Amendments to the Drawings:

Title: IMPACT ABSORBING
STRUCTURE FOR VEHICLE
STEERING SYSTEMS
Inventor(s): Mitsuji YAMAMURA
Appl. No.: 10/733,249

FIG.4

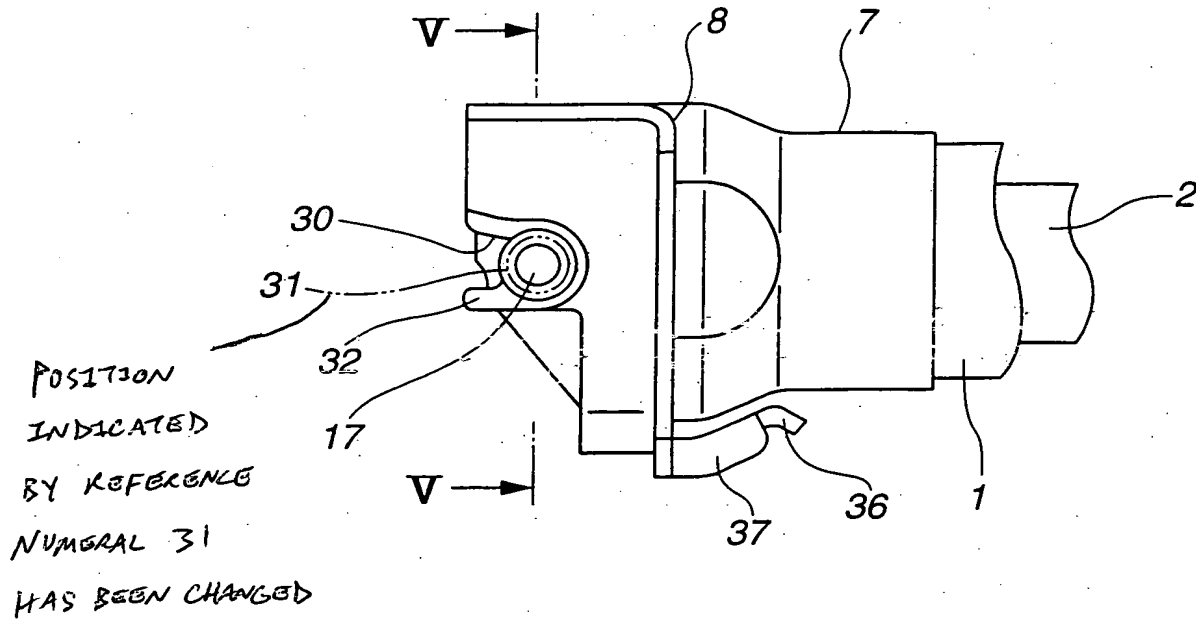
The specific changes which have been made to Figure 4 is to change the position indicated by reference numeral 31.

The drawings are objected to for not showing every feature of claim 9 and because reference characters “17” and “31” have both been used to designate the pivot in Figure 4. The drawings have been amended to overcome these objections. Withdrawal of these objections is respectfully requested.

The drawing sheet attached in connection with the above-identified application containing Figures 4 and 5 is being presented as a new formal drawing sheet to be substituted for the previously submitted drawing sheet. The drawing Figure 4 has been amended. Appended to this amendment is an annotated copy of the previous drawing sheet which has been marked to show changes presented in the replacement sheet of the drawing.
